Value Engineering Report  
Design Development Stage

**STP-9252(6) and STP-9250(1)  
JOHNSON FERRY AND ABERNATHY ROADS  
WIDENING FROM THE  
CHATTAHOOCHEE RIVER TO ROSWELL ROAD  
P. I. Nos. 751300 and 715310  
Cobb and Fulton Counties, Georgia**

December 2006

**Georgia Department of Transportation  
District 7**

## PLAN AND PROFILE OF PROPOSED JOHNSON FERRY ROAD AND ABERNATHY ROAD WIDENING FROM THE CHATTAHOOCHEE RIVER TO ROSWELL ROAD

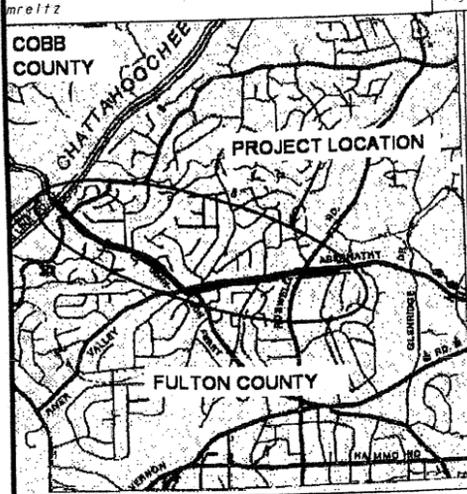
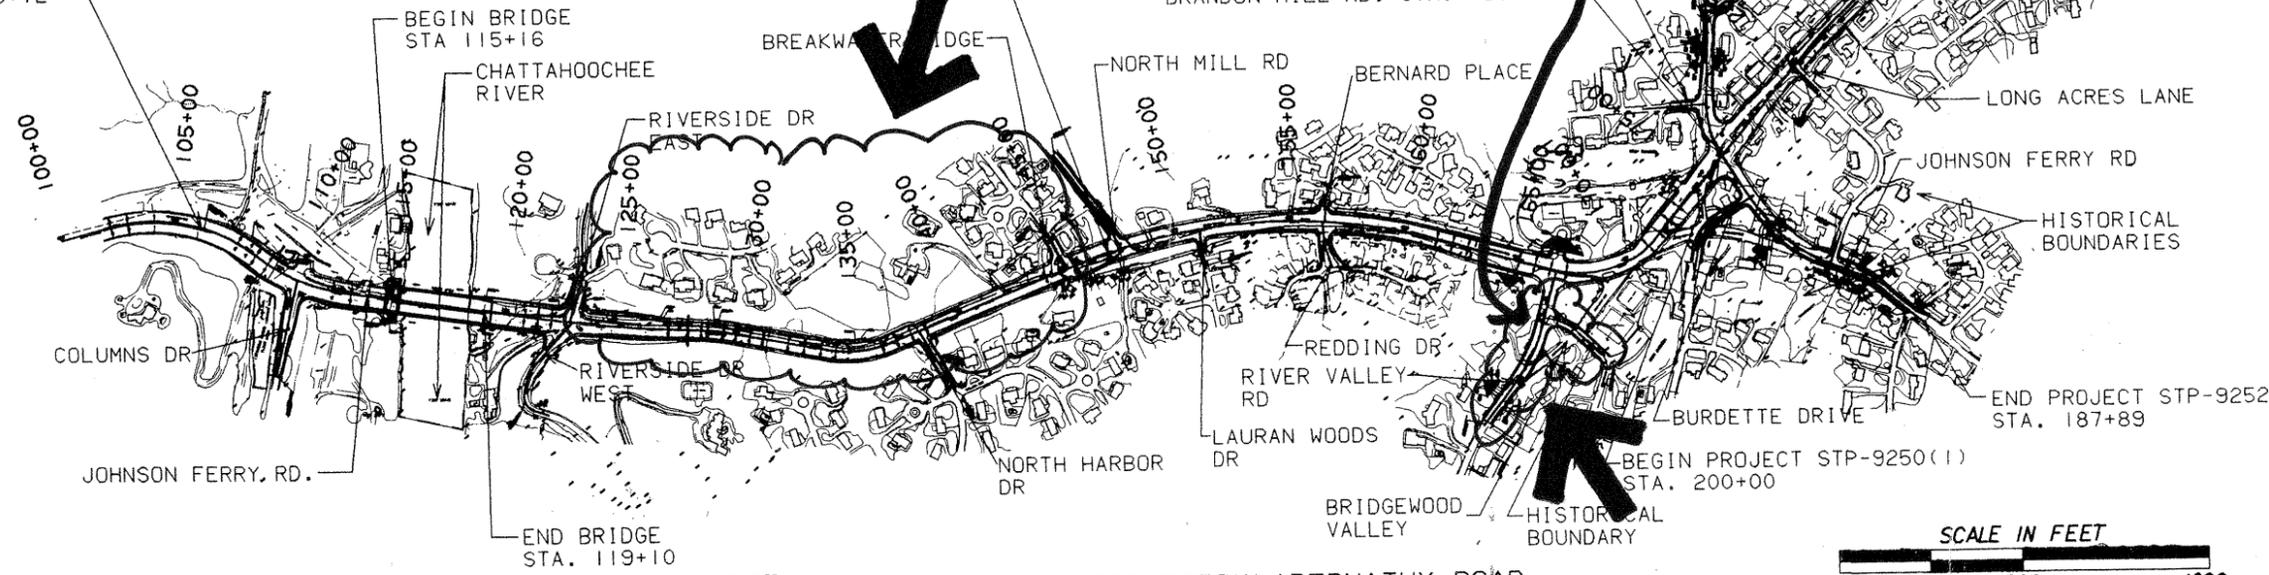
- Does not follow original project scope
- Does not provide a continuous system for pedestrian traffic in either direction
- Loss of a perceived amenity

Sidewalk systems promote pedestrian traffic in close-knit residential and commercial communities such as the area on the east end of the project where existing commercial properties already exist or at Columns Drive on the west end of the project due to the Chattahoochee River National Recreation Area. This project has a unique location for sidewalk and multi-use trails along Johnson Ferry and Abernathy Roads; however, the location on Johnson Ferry Road between Station (STA) 123+00 to STA 145+00, right and left is questionable due to the existence and proposed grades exceeding 5.00% and are not conducive to pedestrian traffic. This is evident from the lack of use of the existing sidewalks on the Cobb County side of the river. As such, elimination the concrete sidewalk paving on this section of the project is appropriate.

**DELETE CONC.  
SIDEWALK PAVING**

TYPICAL DECK SECTIONS  
PROJECT : STP-9252(6)  
NAME: WIDENING C.R. 655 (JOHNSON FERRY RD.) OVER THE CHATTAHOOCHEE RIVER  
COBB-FULTON CO.  
DRAWN BY : ELS  
DATE : APRIL 26, 2005  
SCALE : AS SHOWN  
PREPARED BY : STB

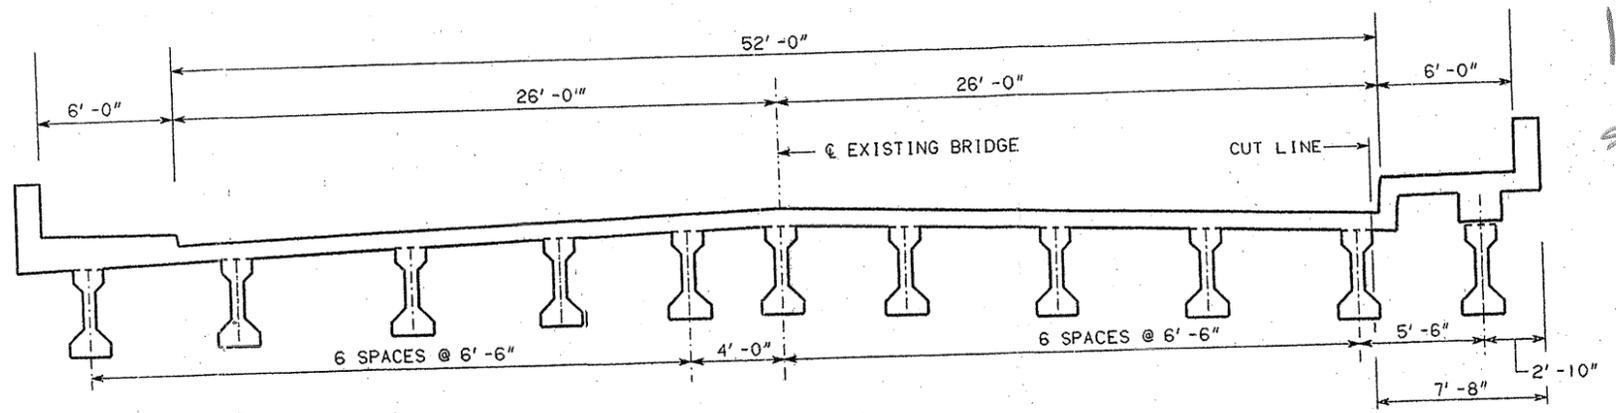
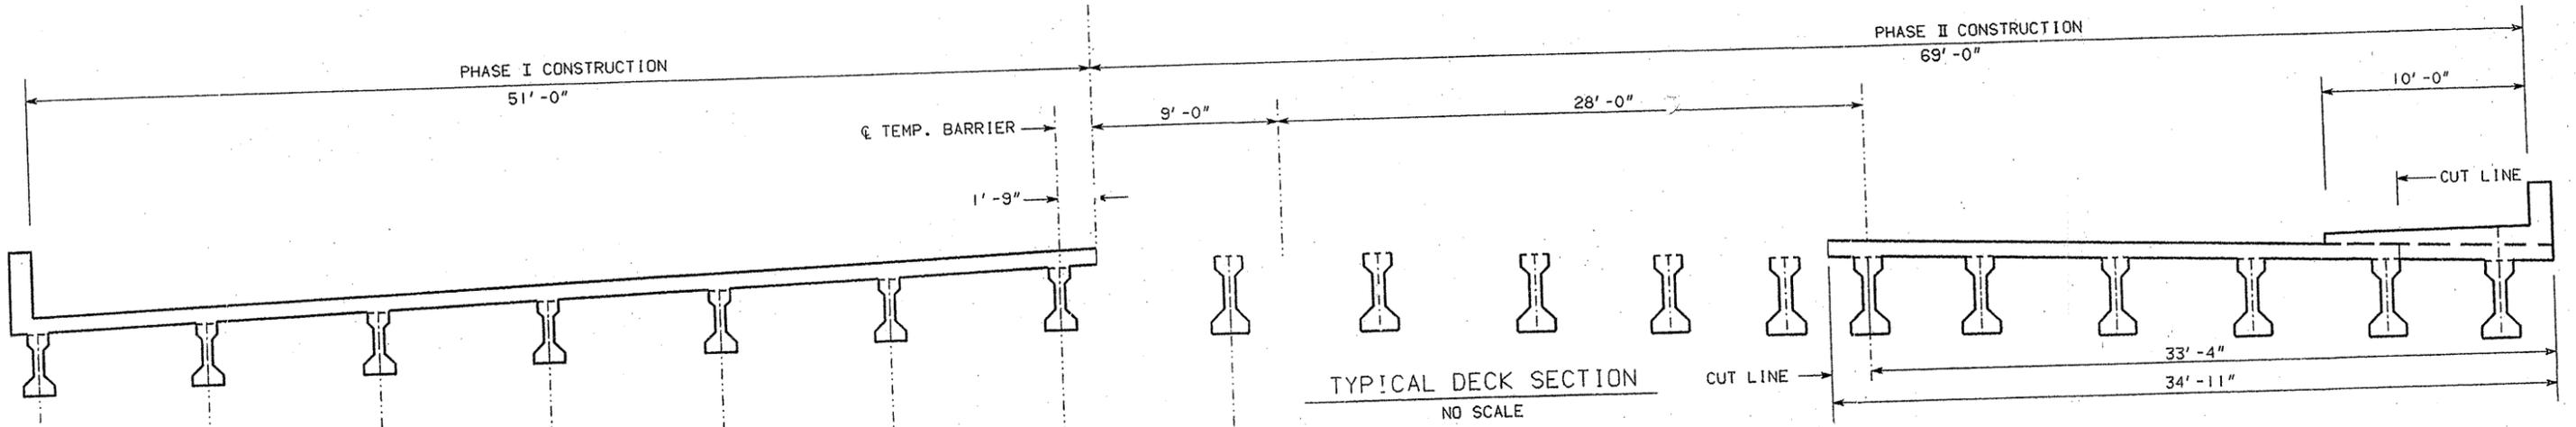
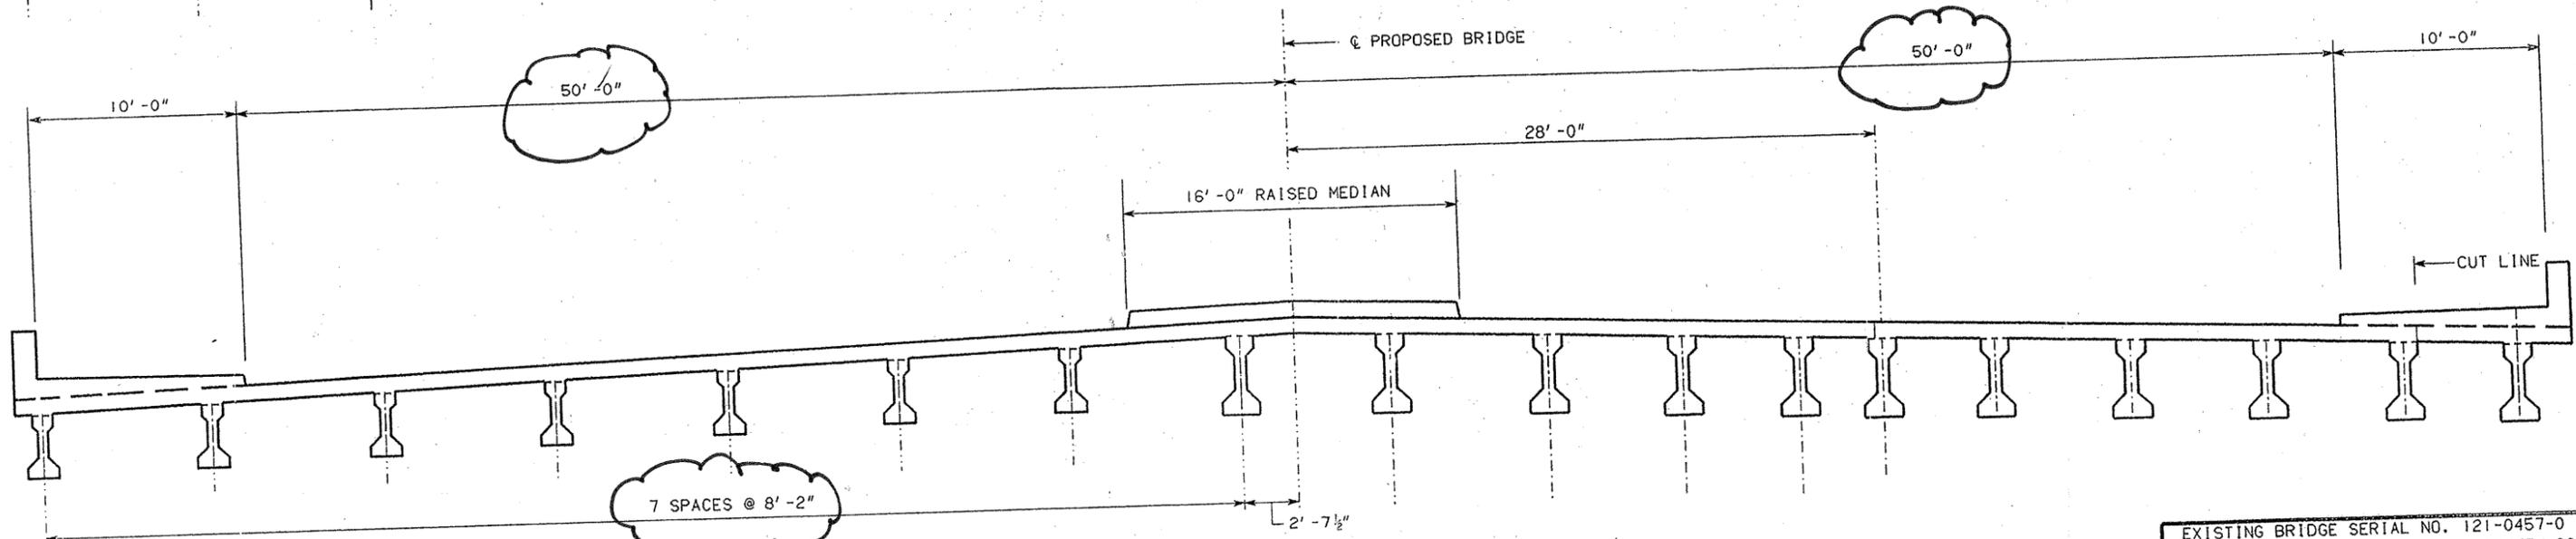
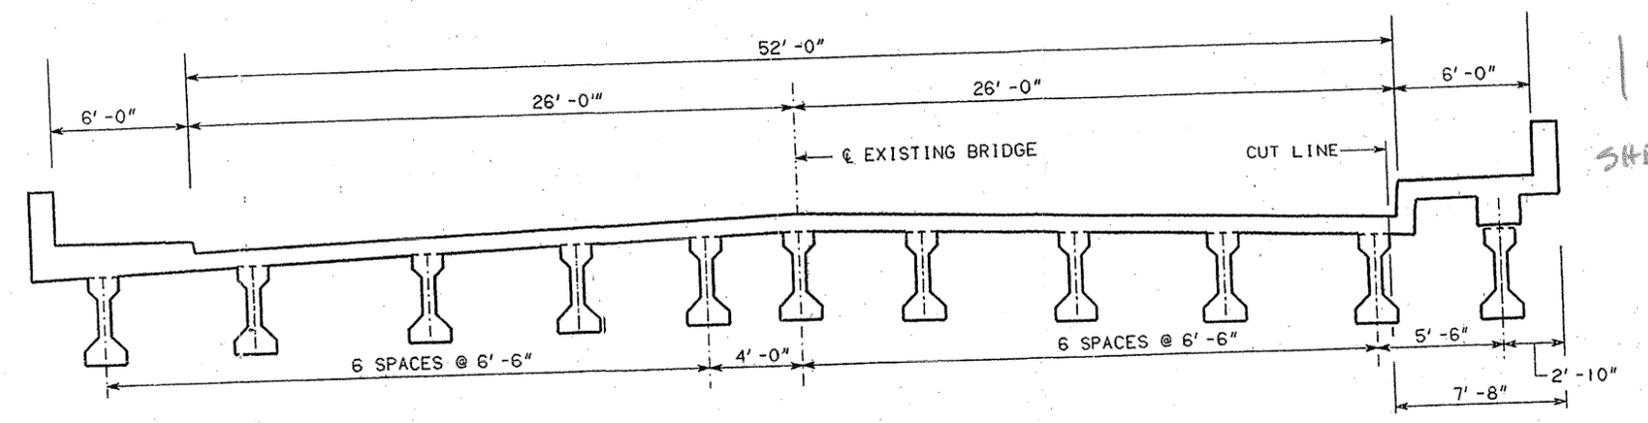
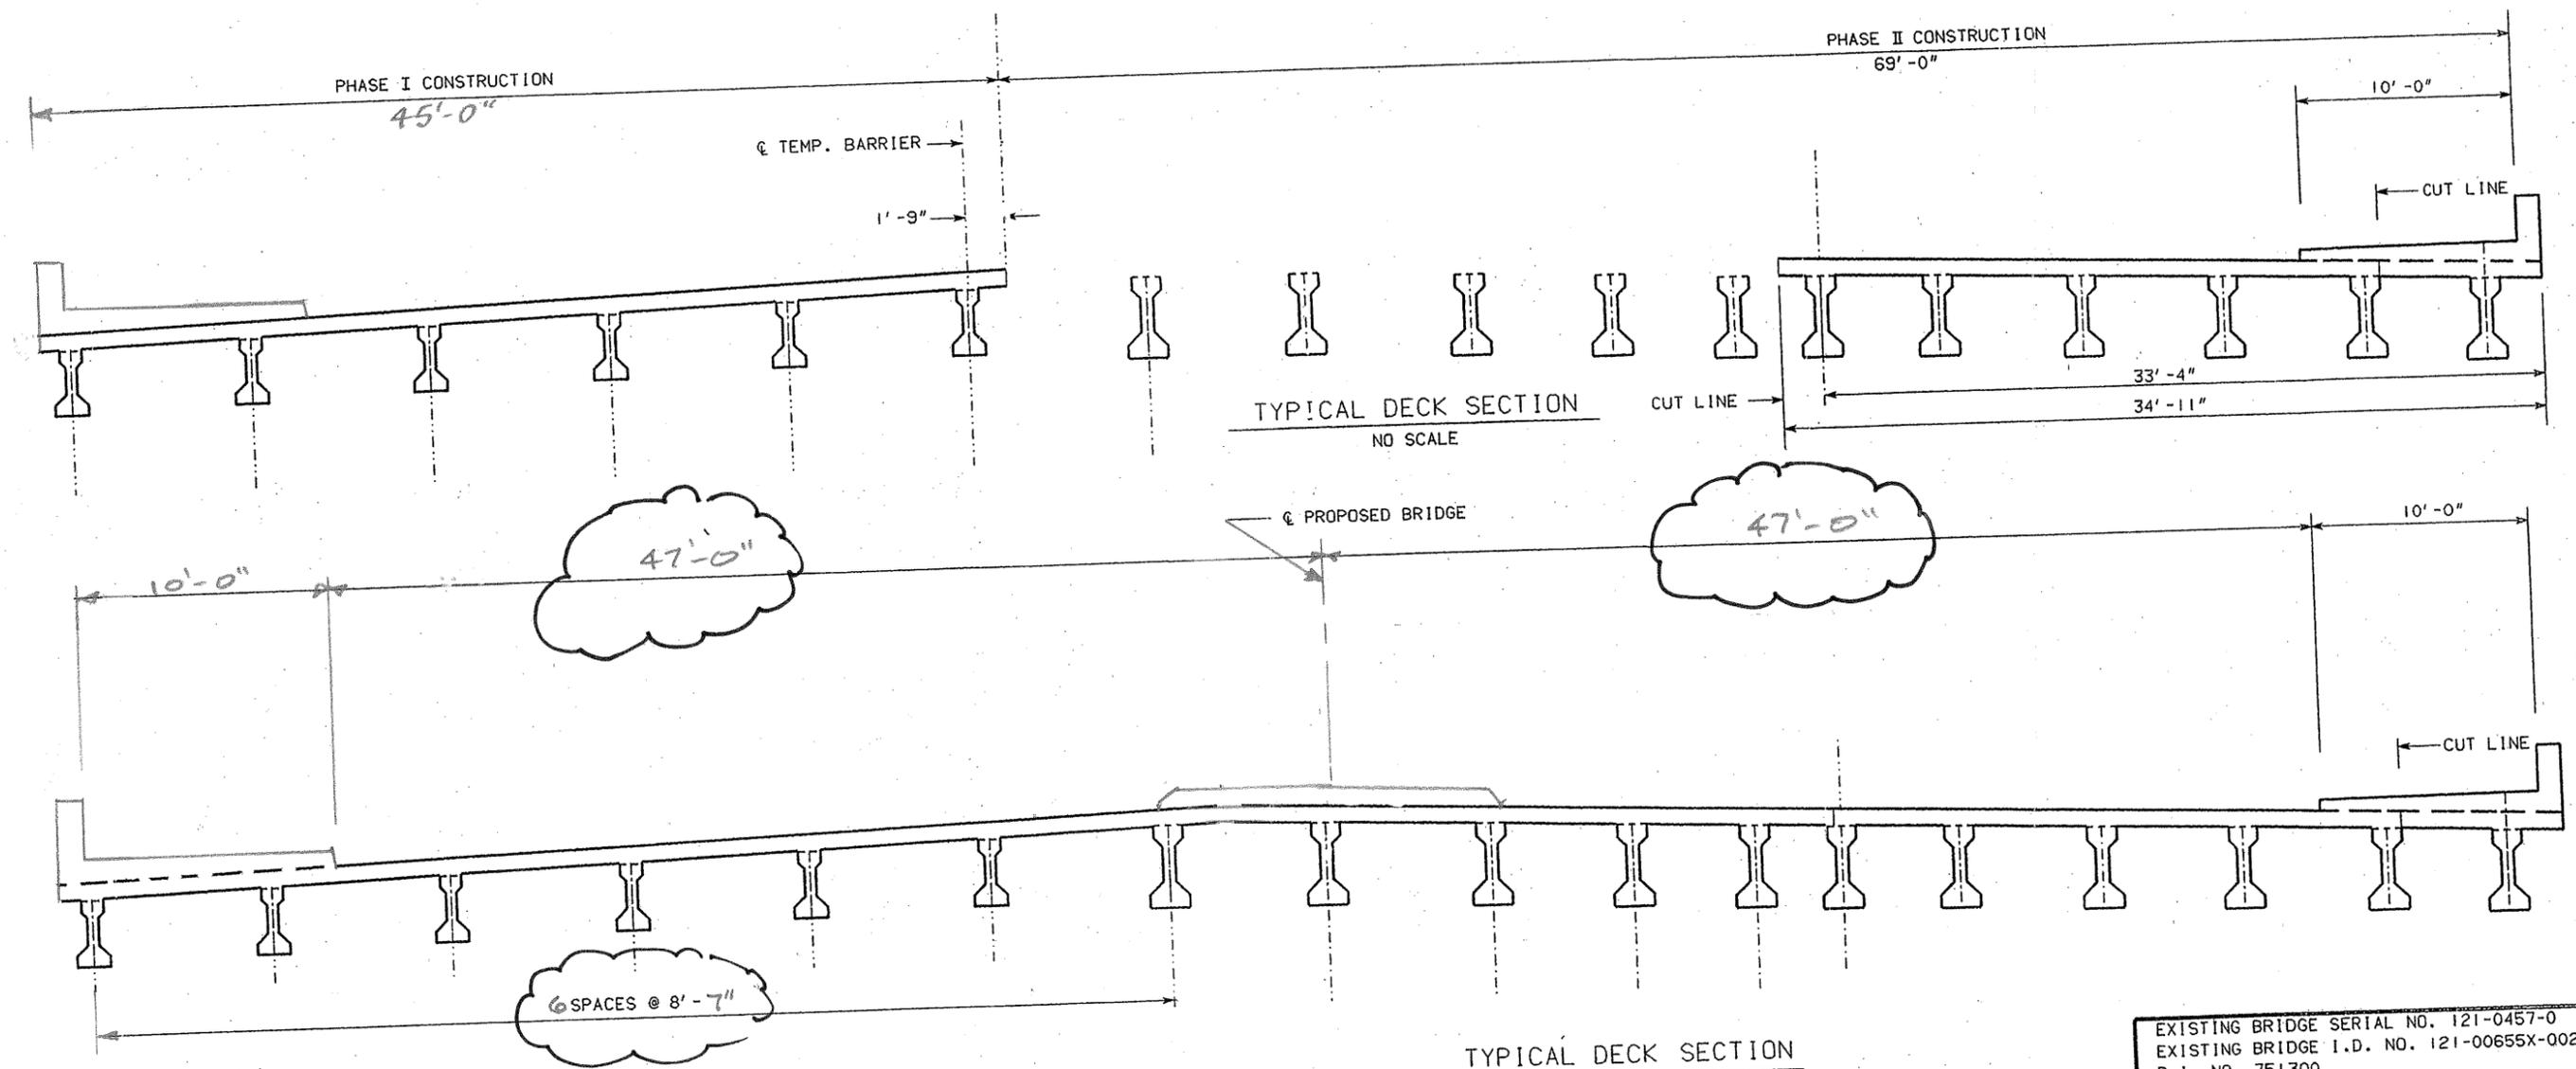
- Perceived loss of safety due to narrower lanes
- Does not match lane width on the north side of Columns Drive

One line of beams can be omitted by increasing beam spacing from 8'-2" to 8'-7". Since 11-foot lanes are used from Riverside Drive to Roswell Road/SR 9, they should be acceptable on the bridge.

The change in travel lane width on Johnson Ferry Road occurs on the south side of the Riverside Road intersection. Since the far right southbound lane on Johnson Ferry Road drops off at Columns Drive, the transition to 11-foot lanes on the bridge would be imperceptible to the commuting traffic. (See related Alternative No. 26.)

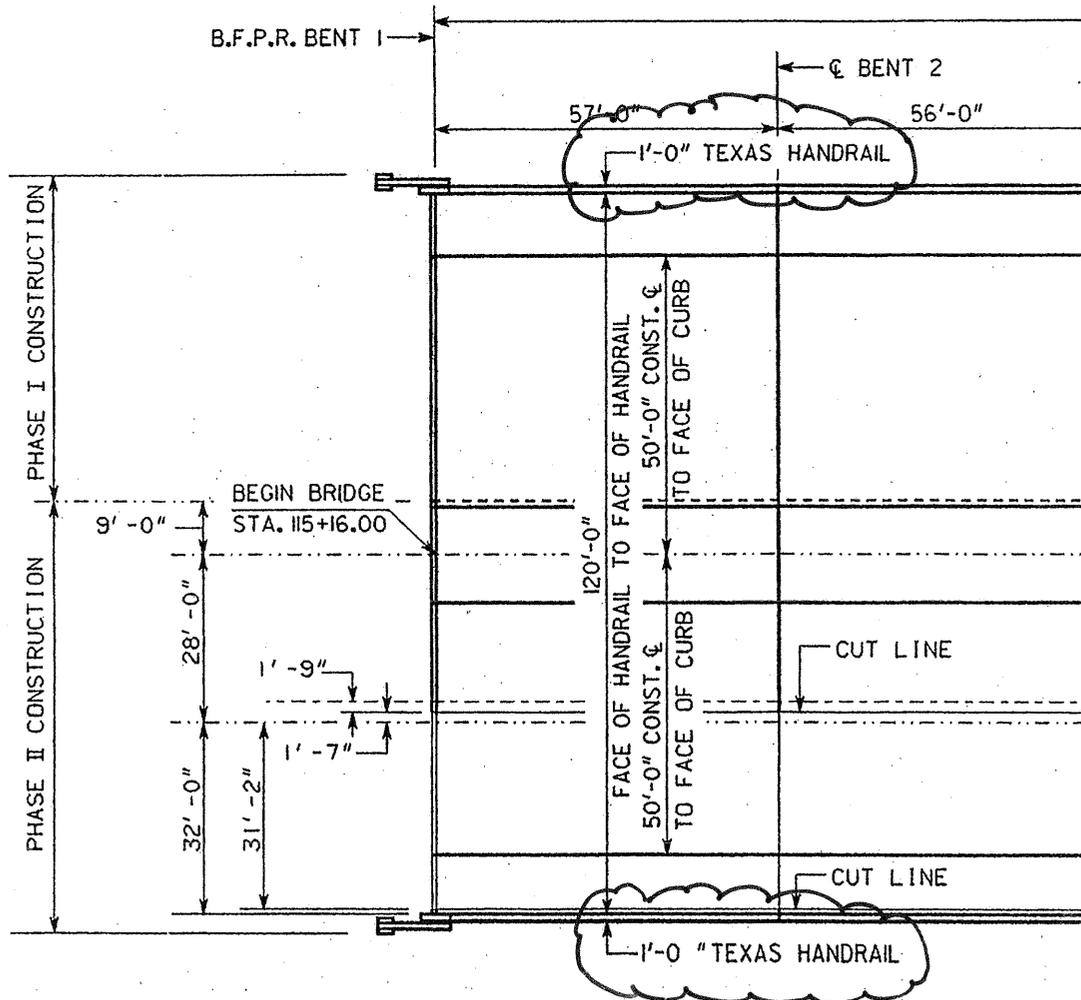
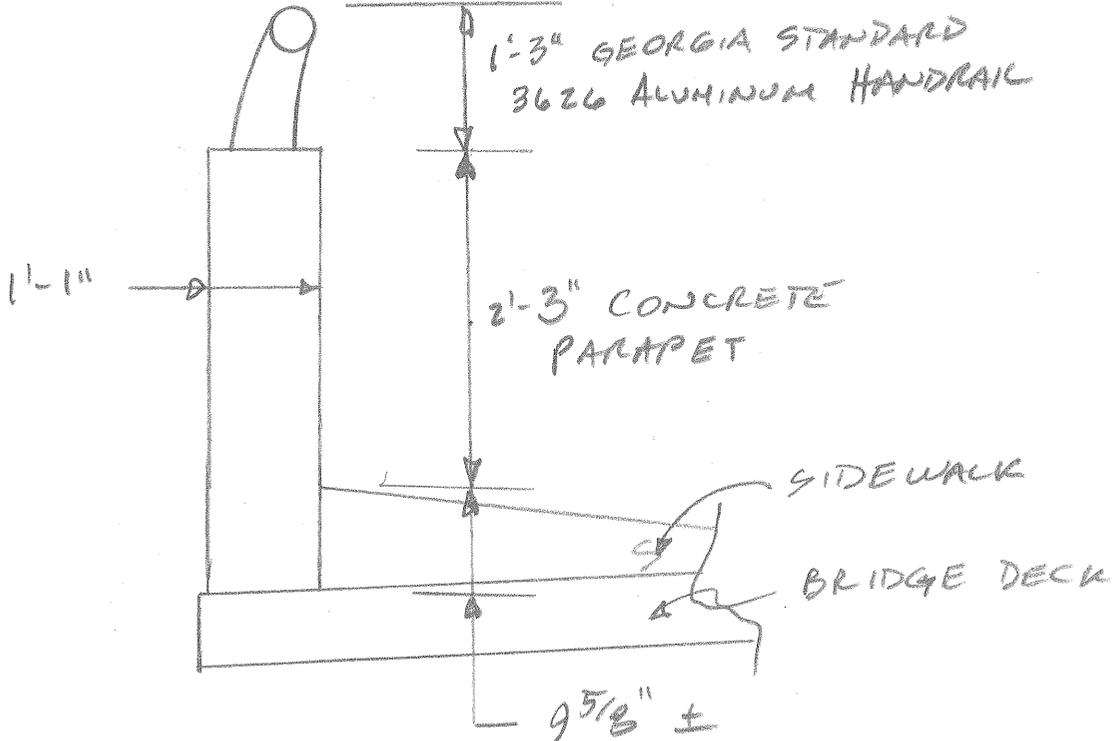
Bridges, particularly the Johnson Ferry Road bridge, are utilitarian in nature. Although this one is in close proximity to the Chattahoochee River National Recreation Area, its aesthetic value may not be appreciated due to the heavy volume of vehicular traffic on the bridge.
